PARK PLACE SUBDIVISION

APPLICATION NUMBER 13 DATE August 21, 2003
APPLICANT Park Place Subdivision
REQUEST Subdivision

DETAIL SITE PLAN

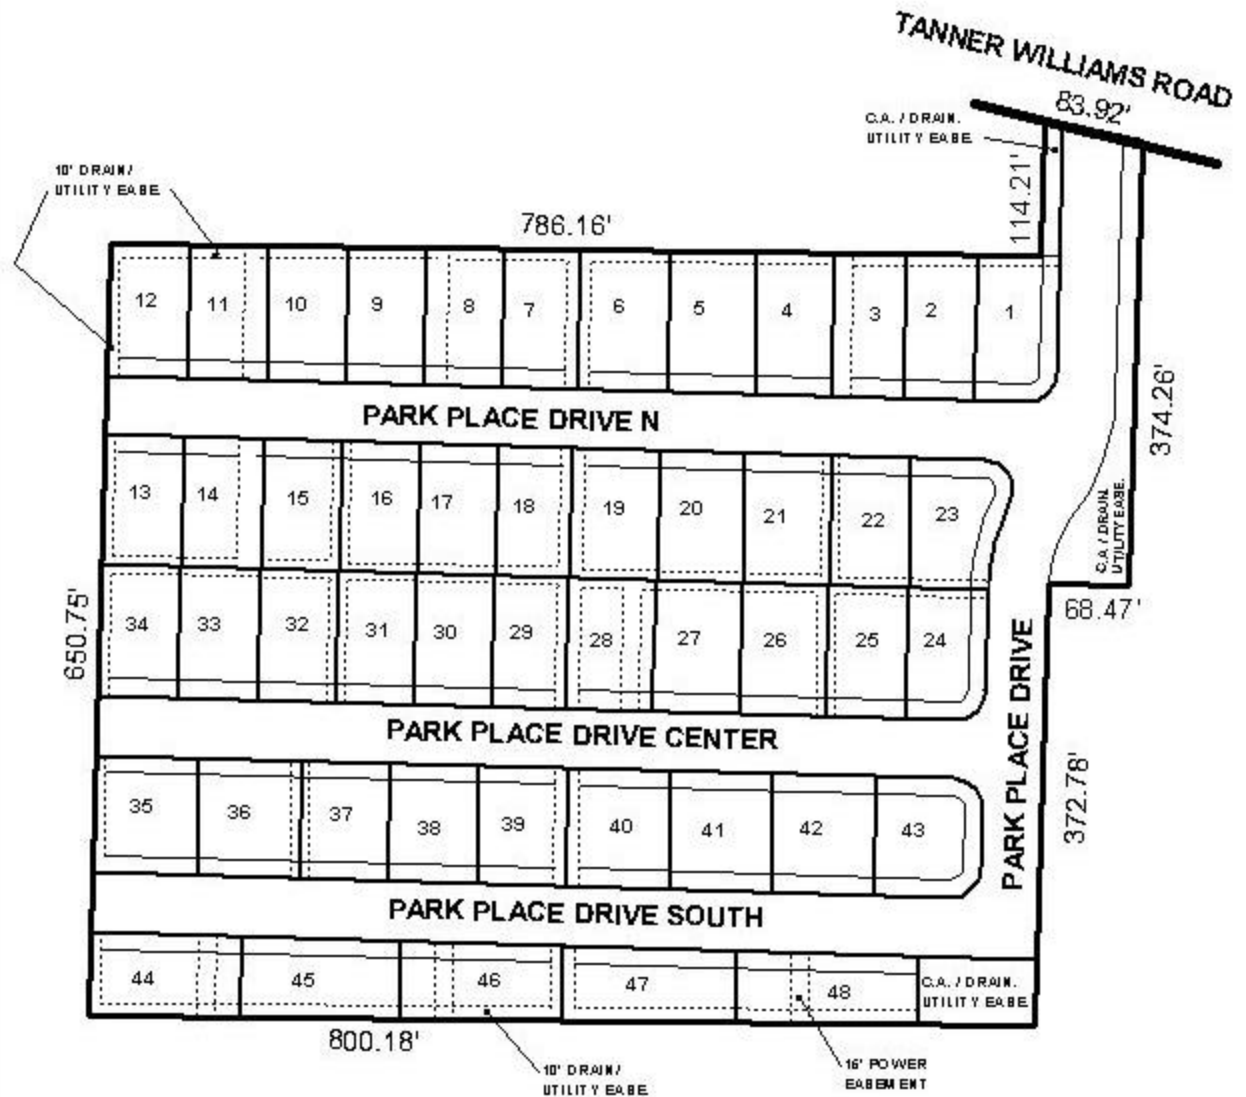
The site fronts Tanner Williams Road, a planned major street, which has an existing right-of-way shown as 60 feet, the Major Street Plan requires a 100-foot right-of-way. Therefore, the dedication from the centerline of Tanner Williams Road, to provide for the right-of-way of the planned major street, should be required.

A note should be placed on the final plat stating that lots located on a corner (Lots 1, 23, 24 and 43) be allowed one curb cut each, with the size, location and design to be approved by County Engineering, should be required. Section V.B.6 of the Subdivision Regulations states that a closed end street shall not be longer than 600-feet. As proposed, the subdivision complies with the Regulations by providing street stubs to the West as required. However, the streets proposed are approximately 700' long; therefore, the requirement of a temporary turnaround should be required. Additionally, the construction of the proposed streets should be constructed to County standards.

This site is located in the County, thus a note should be placed on the final plat stating that any lots which are developed commercially and adjoin residentially developed property must provide a buffer, in compliance with Section V.A.7. of the Subdivision Regulations.

Common areas are shown on the plat, thus the placement of a note on the final plat stating that maintenance of all common areas shall be the responsibility of the property owners, should be required.

The twenty-five foot minimum building setback lines are not shown but would be required on the final plat.

The plat meets the minimum requirements of the Subdivision Regulations and is recommended for Tentative Approval subject to the following conditions: 1) the dedication of sufficient right-of-way from the centerline of Tanner Williams Road; 2) the placement of a note on the final plat stating that corner lots (Lots 1, 23, 24 and 43) are limited to one curb cut each, with the size, location and design to be approved by County Engineering; 3) the placement of a note on the final plat stating that the construction of the proposed streets should be constructed to County standards; 4) the placement of a note on the final plat stating that any lots which are developed commercially and adjoin residentially developed property must provide a buffer, in compliance with Section V.A.7. of the Subdivision Regulations; 5) the placement of a note on the final plat stating that maintenance of all common areas are the responsibility of the property owners; and 6) the placement of the 25-foot minimum building setback lines on the final plat.
